ADDENDUM REPORT:

***Royal Rehabilitation Centre Sydney
(MP 05_0001 MOD 1)***

***Modification of residential layout including
modifications to roads, open space and built
form layouts, building heights and density
within Stage 1.***

Director-General's
Environmental Assessment Report
Section 75W of the
Environmental Planning and Assessment Act 1979

Figure 1: Boundary Setback Plan.
(Correct minimum and maximum setbacks shown in red).

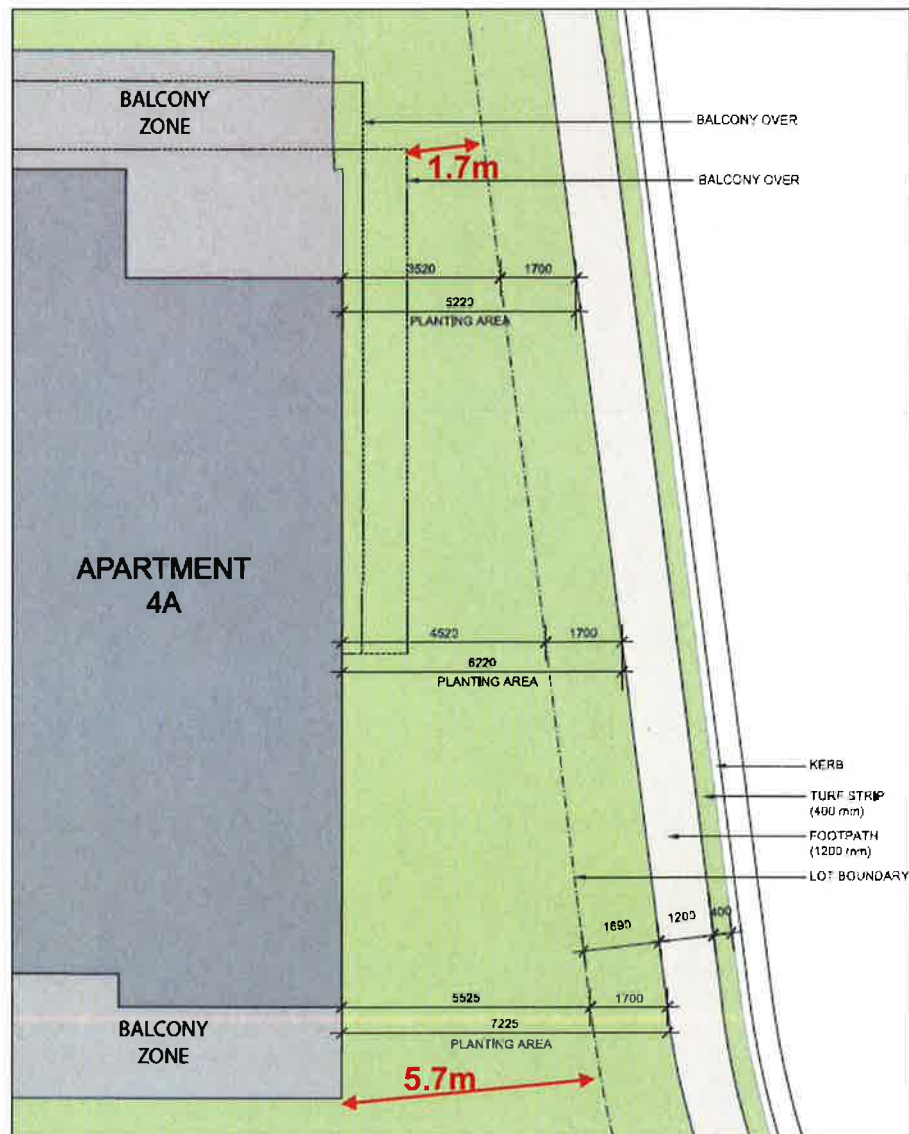
The Department does not support the assessment by the proponent. As demonstrated in **Figure 1**, the proposed building envelope will not provide a setback of 3.52 – 5.52 metres. Once balcony structures are included (which form part of the building envelope), the proposed building would have a minimum setback of 1.7 metres and maximum setback of 5.7m from the Victoria Road boundary.

The proposed balconies, which occur at the first floor level and continue each alternate level to the top floor, will read as part of the building form. With a minimum setback of 1.7 metres, the building, including its balconies, would result in a significant overbearing visual impact on the streetscape.

It is therefore recommended that the proposed condition not be amended.

Figure 2: Extract from proponent's Landscape Plan.

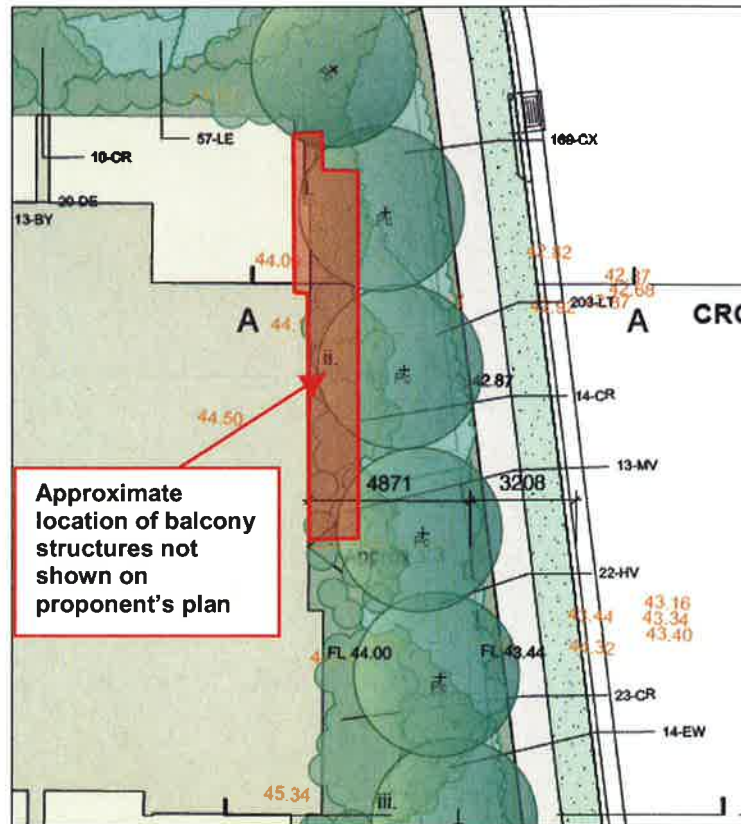
The submitted landscape plans do not show the proposed balconies (refer **Figure 2**). However, as demonstrated by the cross section (**Figure 3**), the proposed building including the proposed balconies, will have a very narrow setback which will result in a significant impediment to the depth of landscaping able to be provided within that setback.

Figure 3: Landscaping Cross Section

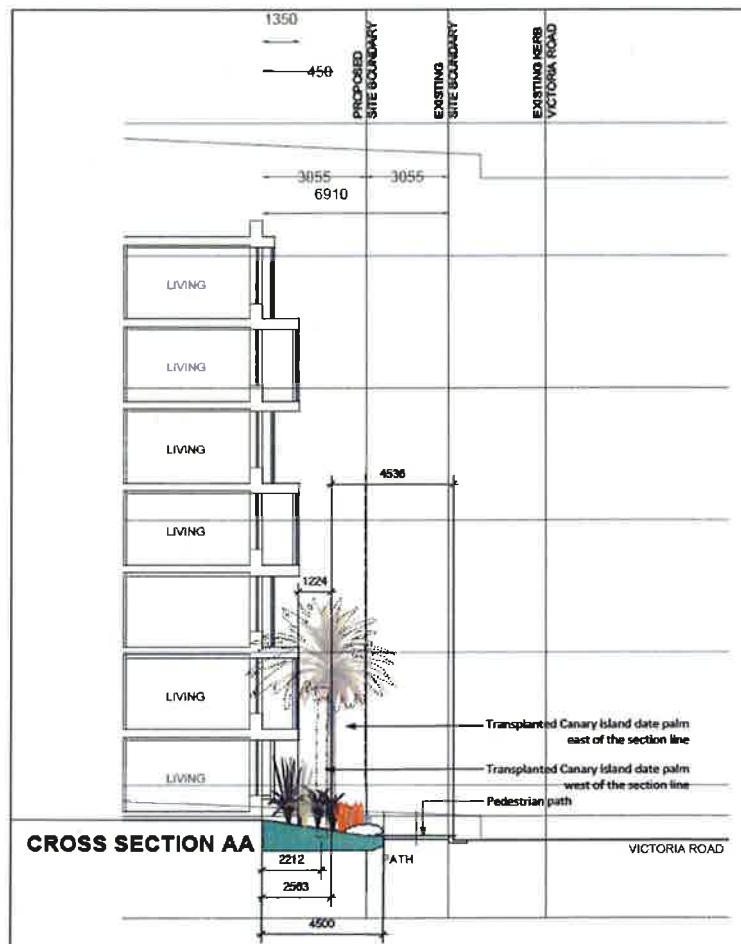
As demonstrated in **Figure 3**, the canopy of the palms will need to be extensively pruned to be kept clear of the building / balconies. Although a statement from the landscape architect was submitted by the proponent, confirmation from a qualified arborist was not provided to confirm the long term viability of the trees within the narrow setbacks. The Department considers that the pruning required to accommodate the reduced building setback would result in adverse impacts to the visual appearance and quality of the trees as well as jeopardising their health and longevity.

Also as shown by the section, the remaining landscaping would be limited to small shrubs and ground covers that are partially under first floor balconies. This raises concerns over the longevity of the landscaping and its contribution to the streetscape.

Figure 4: Extract from Indicative Car Parking Plan showing extent of basement areas

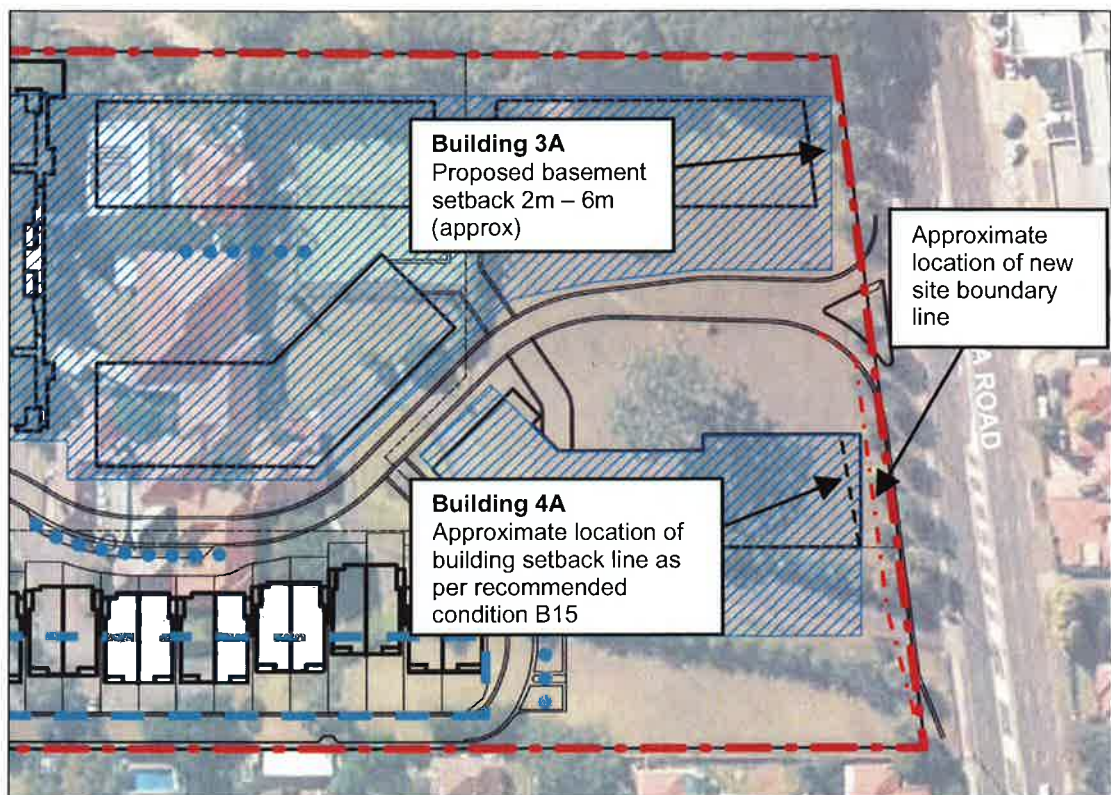
As shown in the **Figure 4**, the proposed development includes basement parking below the front setback of western building (Building 3A) and below what would be the front setback of the eastern building (Building 4A) as modified by recommended condition B15.

The above-ground building envelope of Building 3A would have a setback of approximately 7.5 metres. Despite the calculations given by the proponent, the plans submitted as part of the modification indicate that the basement car park could extend beyond the building by as much as 5.5 metres and to within 2 metres of the boundary with Victoria Road.

Given the relatively small setbacks of the proposed buildings (5.0m and 7.5m), it is essential that the setbacks are able to support high quality landscaping including deep soil zones to support the significant palm trees to be transplanted.

It is therefore considered that the previously recommended condition could be amended to require that no basement parking or below ground structures be provided *within 5 metres of the boundary*.
